Service Letter No. 136A

TO: Owners of PA-20 and PA-22 Airplanes with serial numbers
20-1 through 20-923 and 22-1 through 22-775

SUBJECT: Chafing of Fuel Line and Fuel Valve Operation

Sketch for Service Letter No. 136A

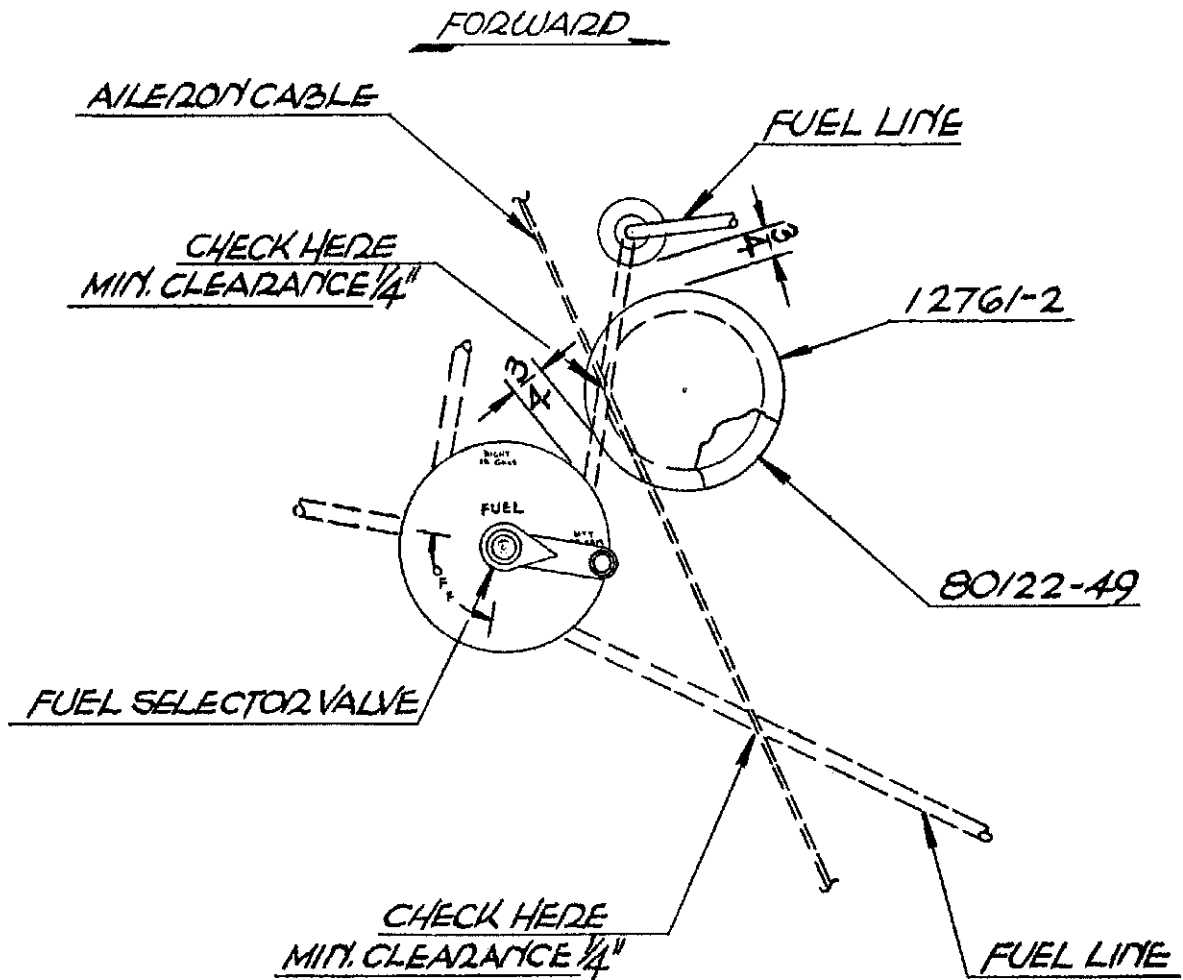
It is necessary that an inspection be made of the aluminum fuel lines forward of the fuel valve.

To accomplish this, dope the pyralin grommet, 80122-49, to the fabric inside the cabin as shown in the sketch. Cut away the fabric enclosed within the grommet.

Inspect the fuel lines for evidence of chafing by the aileron control cable. Check the clearance between the fuel lines and the cable. If 1/4" or more clearance exists no further action is required. If 1/4" minimum clearance has not been provided, form the fuel lines by hand to obtain this minimum clearance. Exercise care while forming to avoid crushing or kinking the fuel lines.

Upon completion, install the cover, 12761-02, as shown in the sketch.

Further inspect the main fuel line for clearance at the rudder pedal torque tube arm. This inspection may be accomplished through the existing opening in the fabric. If adequate clearance is not provided, form the fuel line in the manner indicated above.
